Limestone paving repairs
Scale 1:50

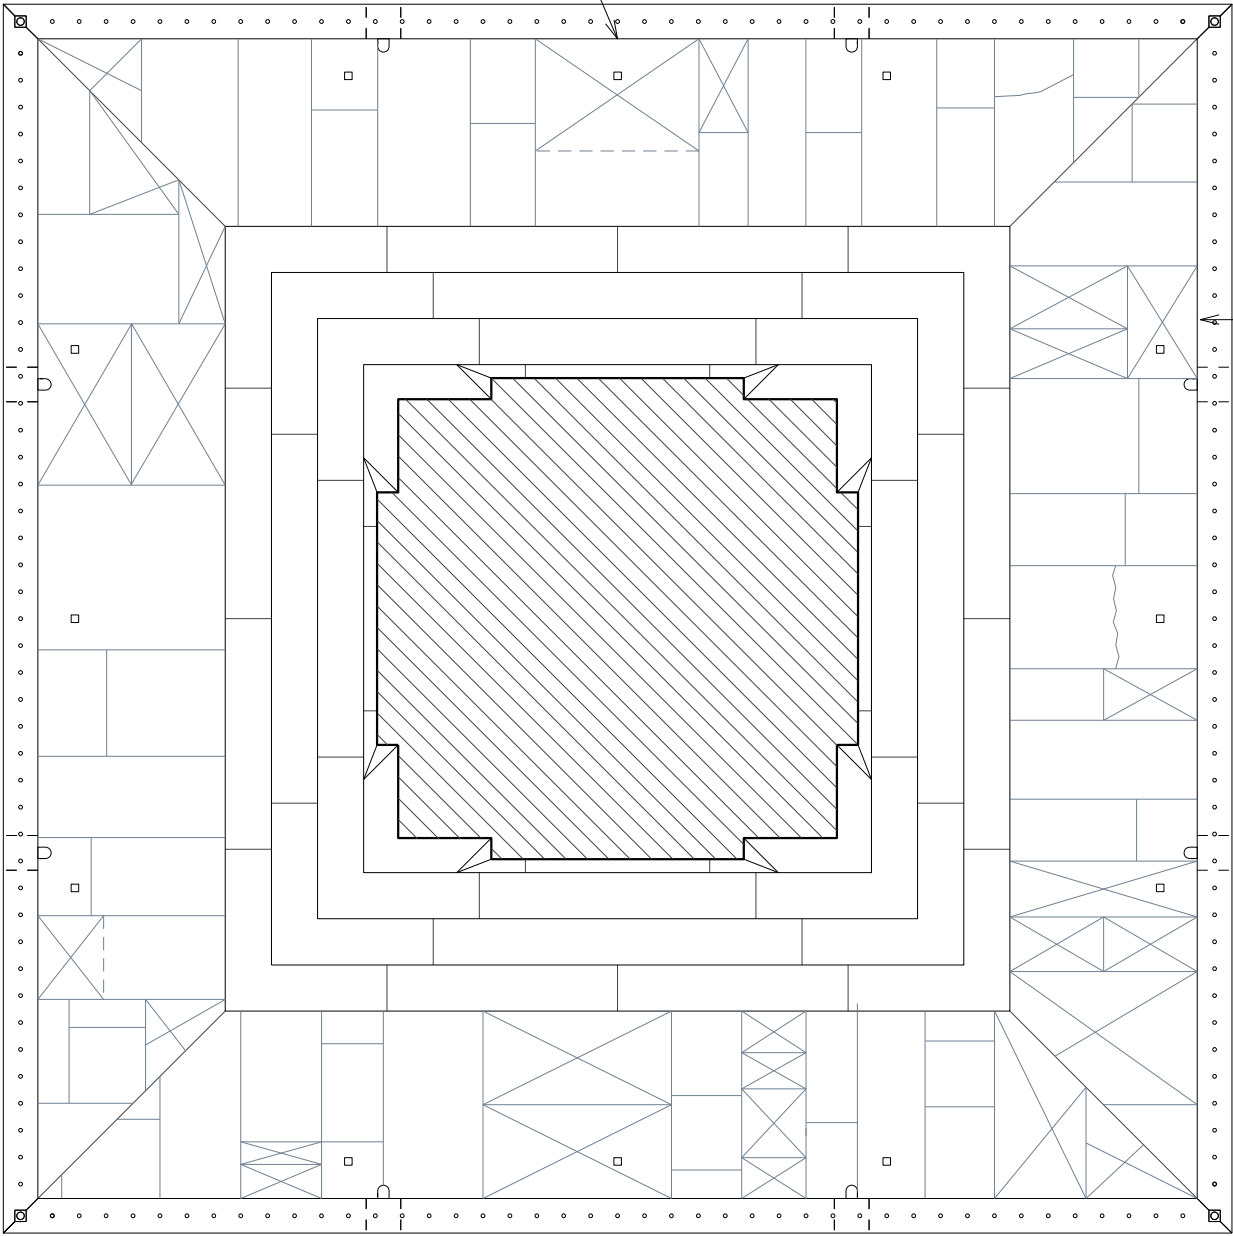
agree 1 No. access point for
rodding of channel drain per elevation

typical - stones to be replaced
